CITY OF GRAND JUNCTION, COLORADO

MEMORANDUM

Subject: Flood Plain Permit - Rusty Sun Subdivision

PROJECT: Indian Wash Flood Analysis

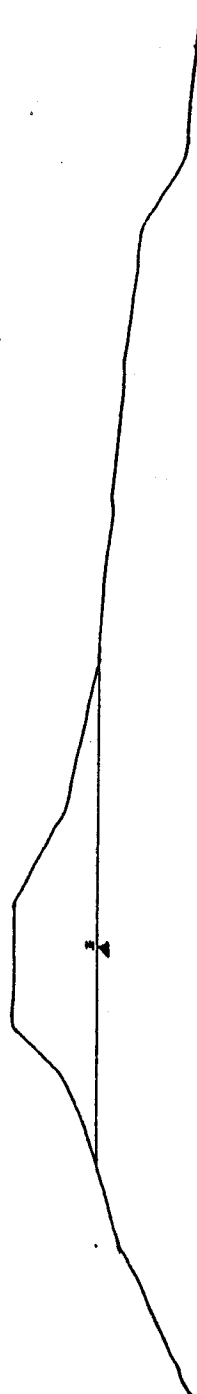
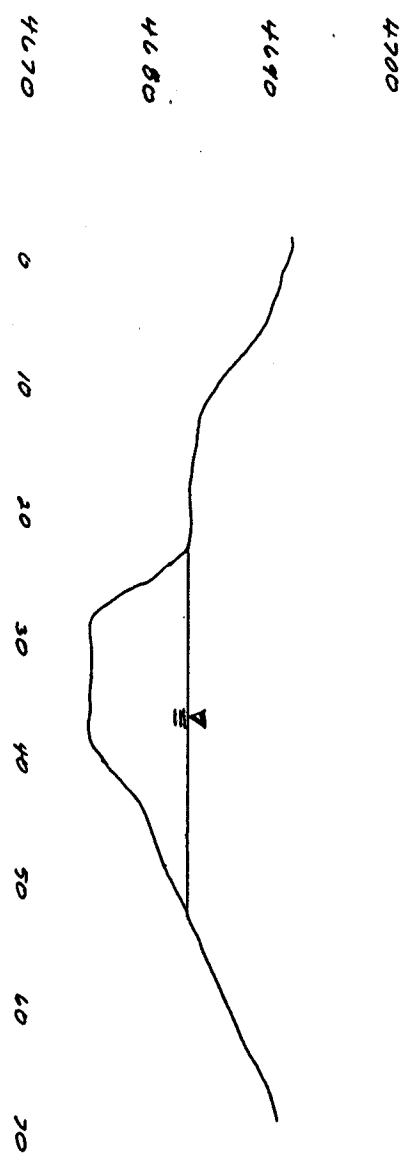
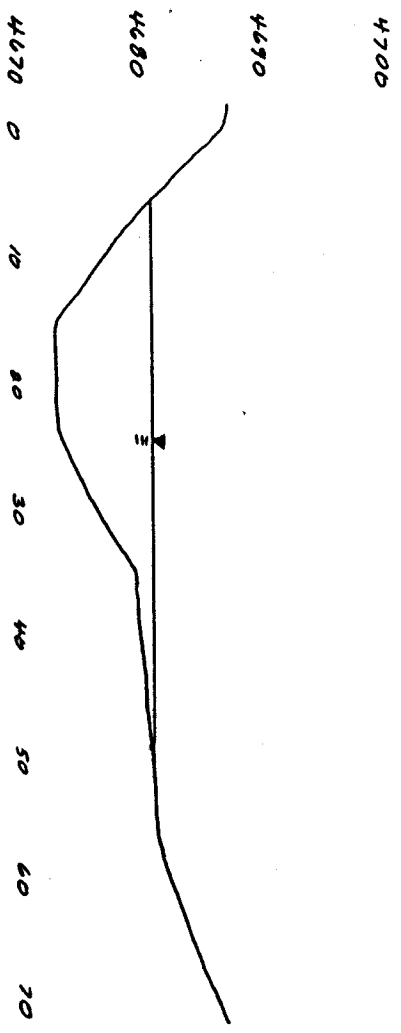
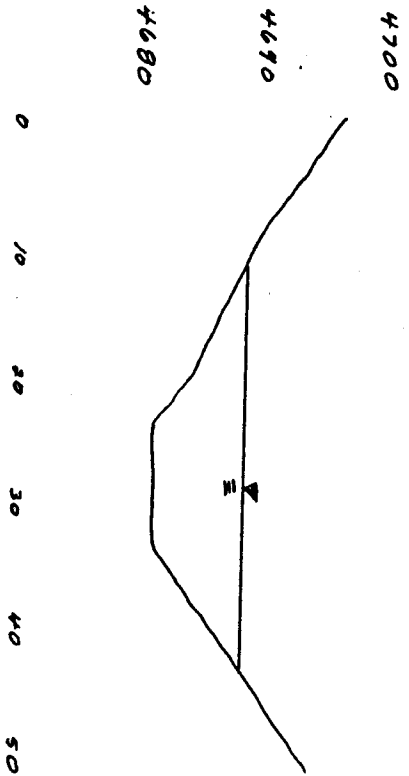
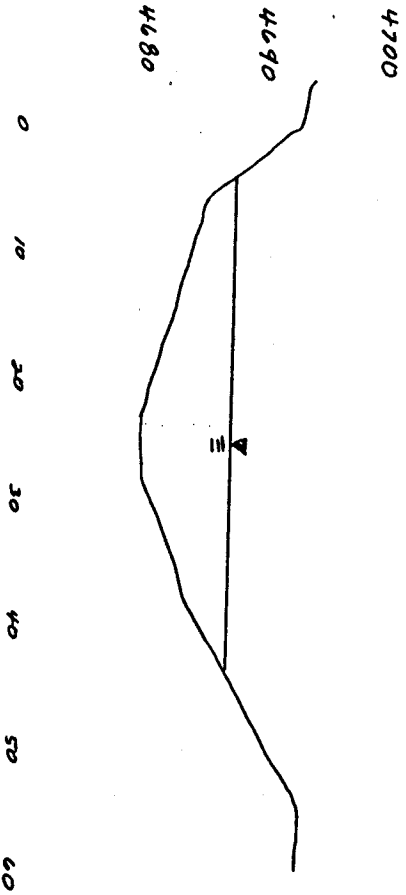
1. I take no exception to the qualitative analysis but disagree with some of the quantitative analysis. Specifically, I do not believe the estimated flood elevations shown which are based on localized analysis at each cross-section without any stream profile "smoothing".

Sheet 12 of 14 shows the following data:

Section DD	Flood elev. = 89.0
Section AA	Flood elev. = 88.0
Section EE	Flood Elev. = 88.0
Section BB	Flood Elev. = 84.0
Section CC	Flood elev. = 81.5

This results in the following:

DD to AA	Water surface drop = 1 ft. length = 110 ft.
AA to EE	Water surface drop = 0 ft. length = 120 ft.
EE to BB	Water surface drop = 4 ft. length = 140 ft.
BB to CC	Water surface drop = 3.5 ft. length = 410 ft.

SUBJECT: Culvert @ 29 & F Rd. by Mesa Co.

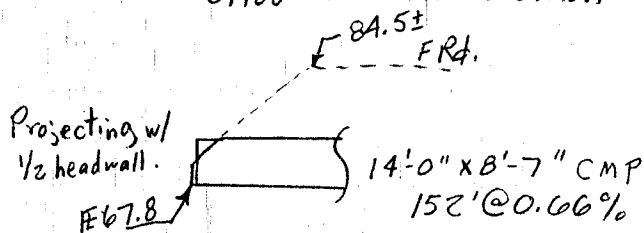
Ref. 1 states $Q_{100} = 950$ to 1000 cfs

(Note: MSM "Hydrologic Analysis, Indian Wash", Jan, 1980 estimates Q_{100} at this location = 1230 cfs)

Check Headwater Pond Elev. for Q_{100}

for $Q_{100} = 1000$ cfs	HW/D = 1.2	HW = 10.2 ft.	HW elev. = 78.0
for $Q_{100} = 1230$ cfs	HW/D = 1.5	HW = 12.8 ft.	HW elev. = 80.6

Pond @
4680.6
for
Q₁₀₀ = 1230 cfs

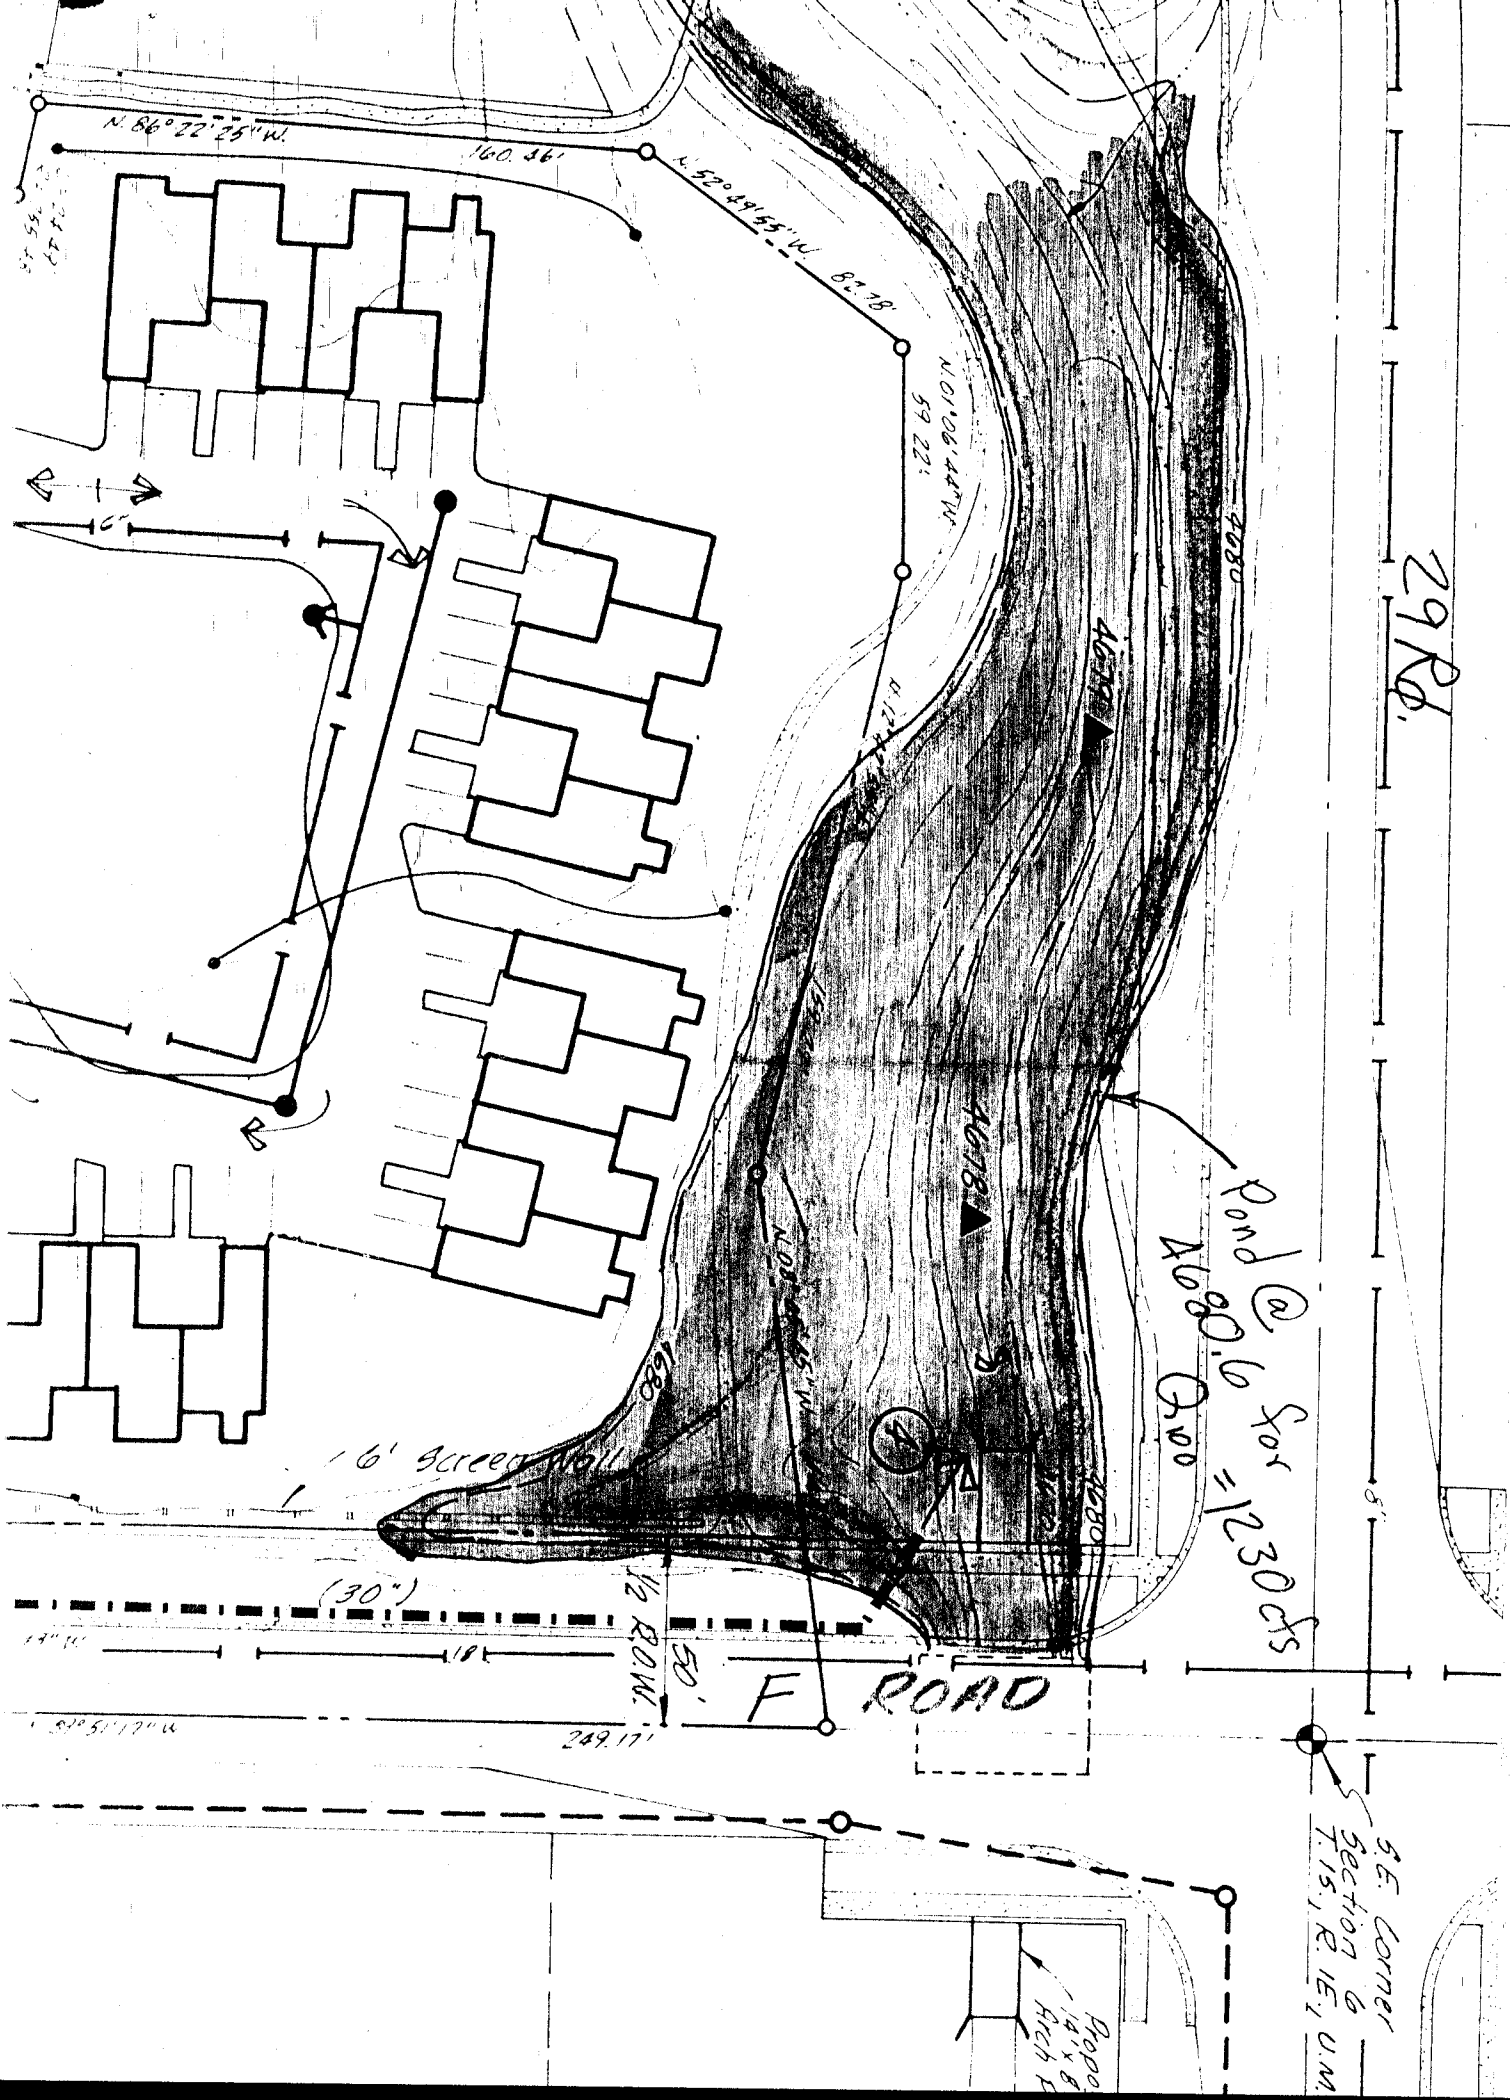
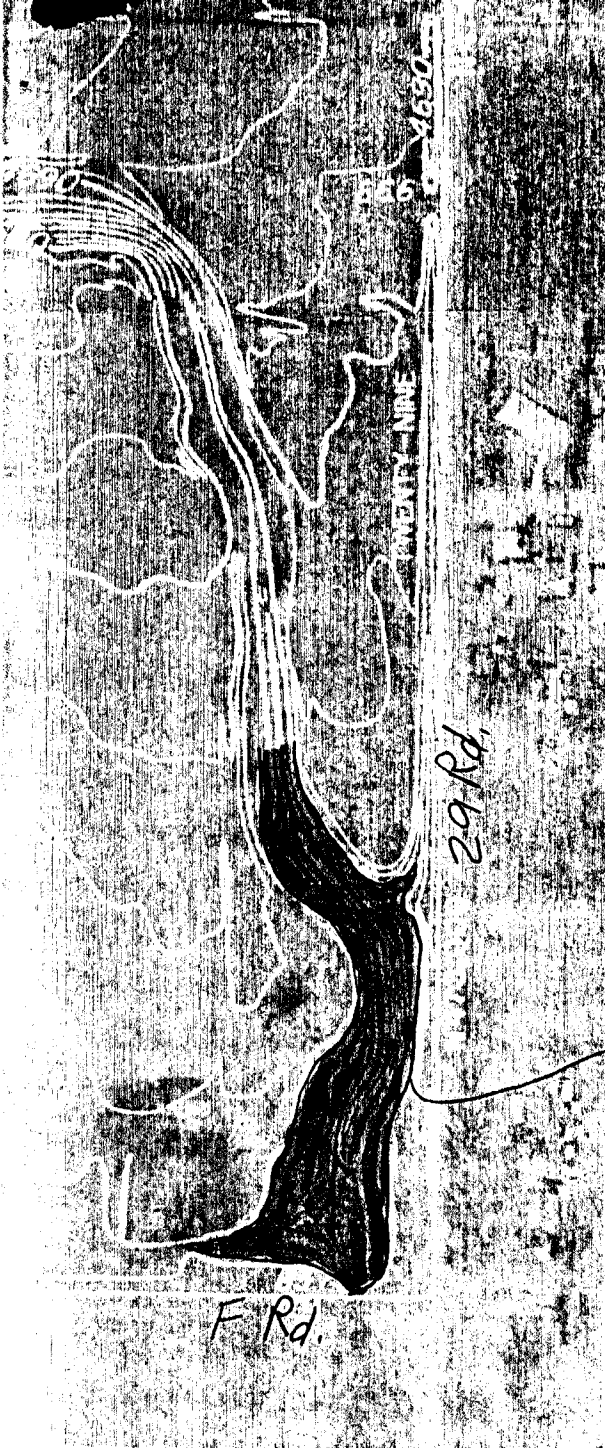
cc: Bob Goldin w/ 2 maps showing Q_{100} ponding
